*Editing Instructions: Replace Subclause 142.2 with the following. Note this document shows changes from CI 142.2 via MS Word mark-up.*

## 142.2 Physical Coding Sublayer (PCS) for 100G-EPON

Figure 142- 1 PCS Functional Block Diagram

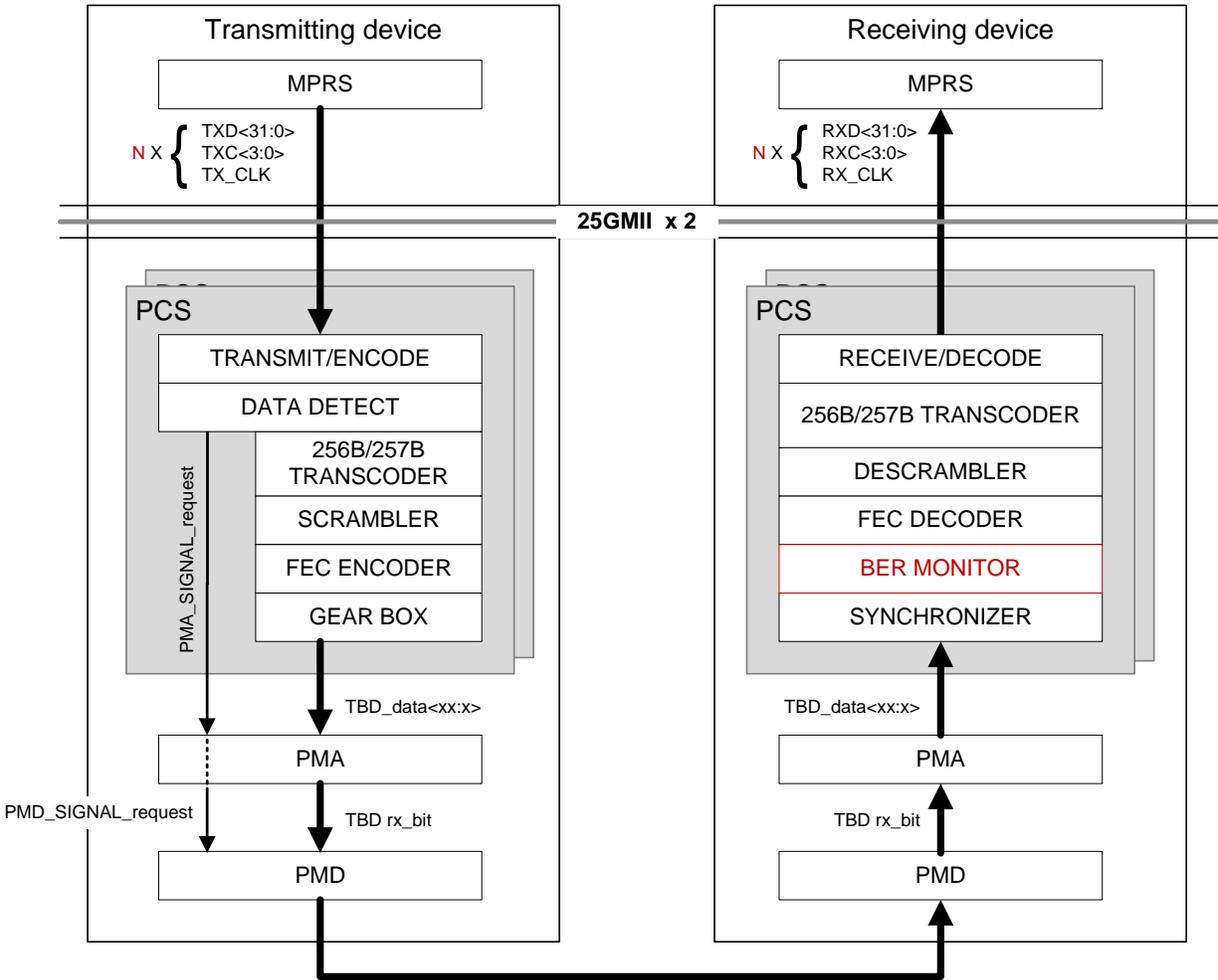
*Note to Editor: red color in above figure is to illustrate difference between this figure and that approved in motion #4 in Geneva 1801 meeting. Draft should only use black ink.*

Figure 76-19—PCS Receive bit ordering

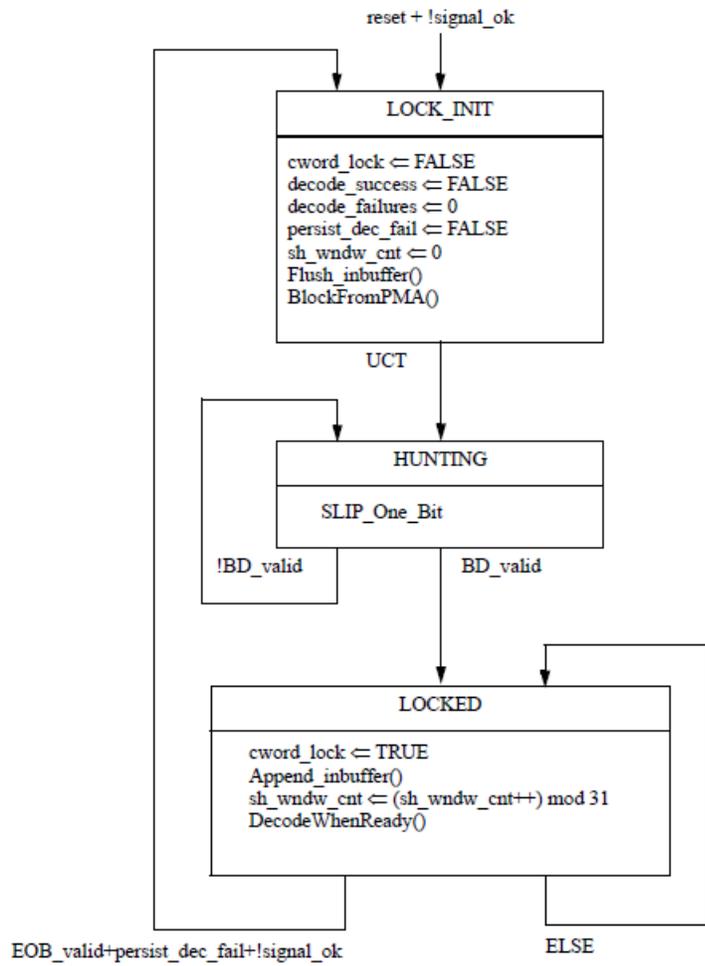
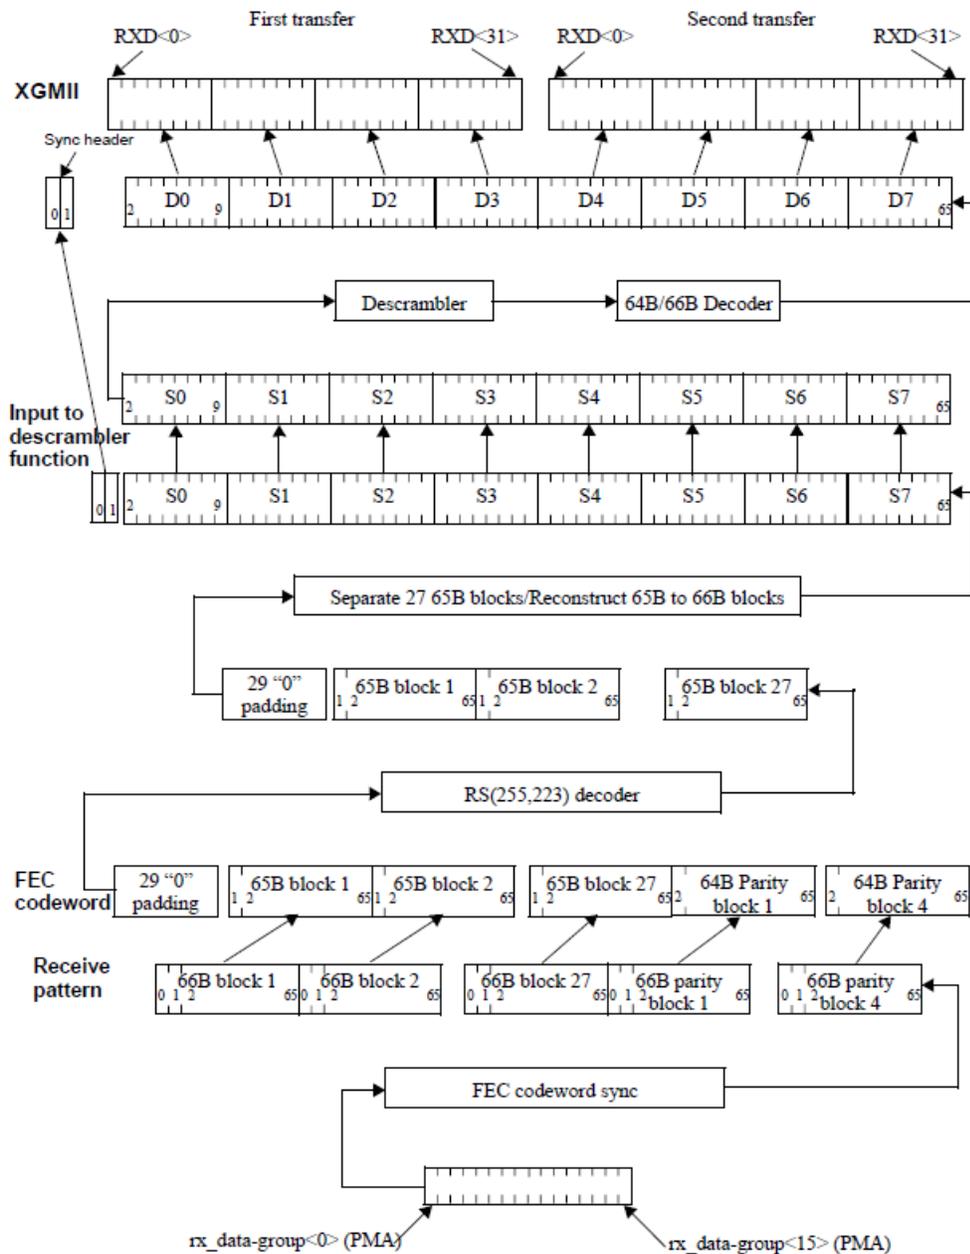
*Editorial note: I've include Fig 76-18 & 76-19 for ref only. Given we are using 256B/257B I suspect these will need to change. Fig 76-19 will change for sure. These figures ar not to be included in the draft.*
